# ***Interactive comment on “Physics-inspired integrated space-time Artificial Neural Networks for regional groundwater flow modeling” by Ali Ghaseminejad and Venkatesh Uddameri***

**Ali Ghaseminejad and Venkatesh Uddameri**

Received and published: 16 June 2020

**Fig. 1.** Figure 5. Well hydrographs at select training wells during the calibration period 1956–2008 (also see Fig. 2b for well locations)

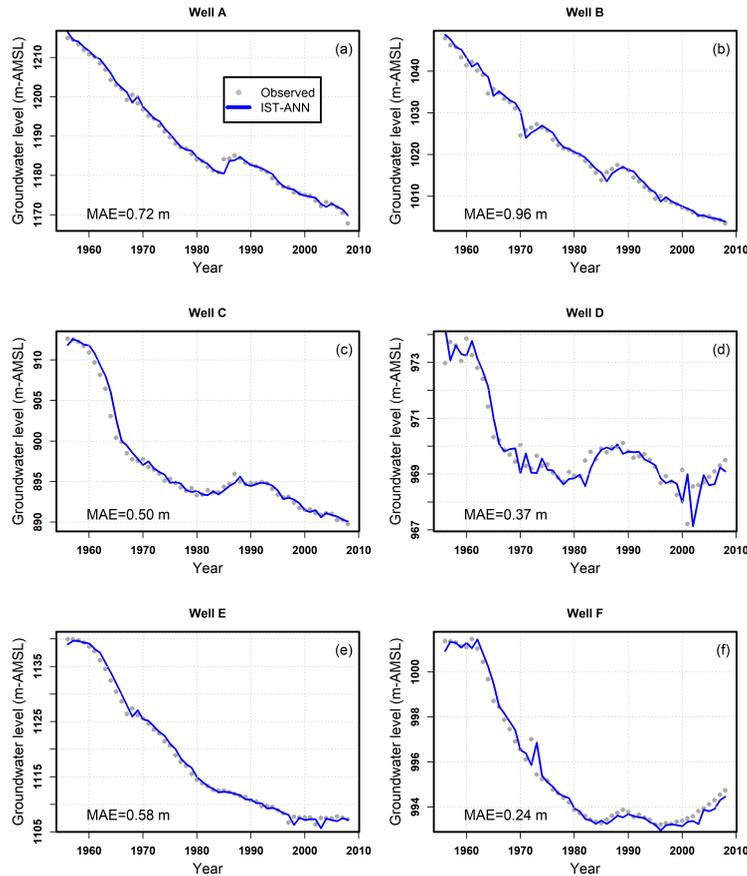
Comment: Page 14: Figure 5. And Figure 7: Y-Axis levels are not visible.

Response: Thank for your suggestion. We have increased the font of the axis labels to make them more visible. (Please see attached Figures).
